Technical Service Bulletin

TSB0118
Rear Sprockets for 50's

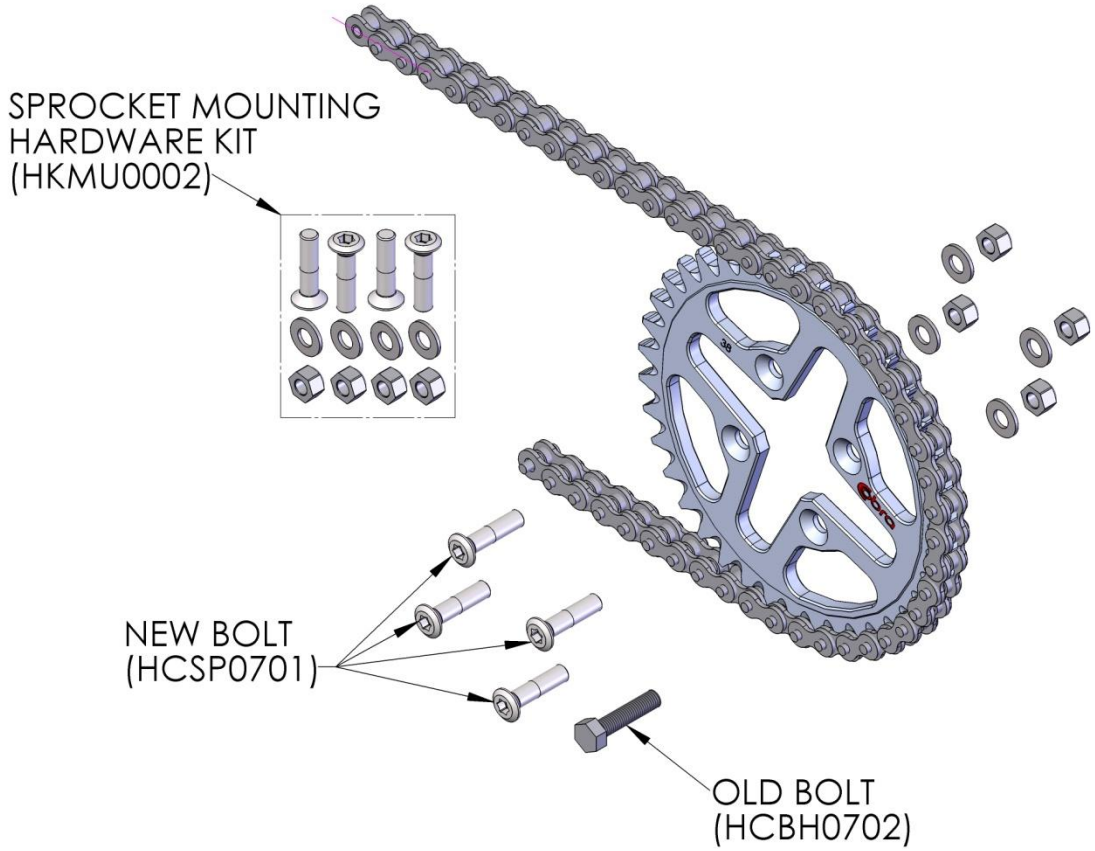
From this time forward, Cobra will only be producing rear sprockets (both 420 & 415 style) that work with our new and improved dedicated sprocket mounting bolts (HCSP0701) instead of the old hex head bolts.

Cobra has available HKMU0002 which includes all necessary hardware (4 bolts, 4 washers & 4 nuts) for mounting the new style sprockets.
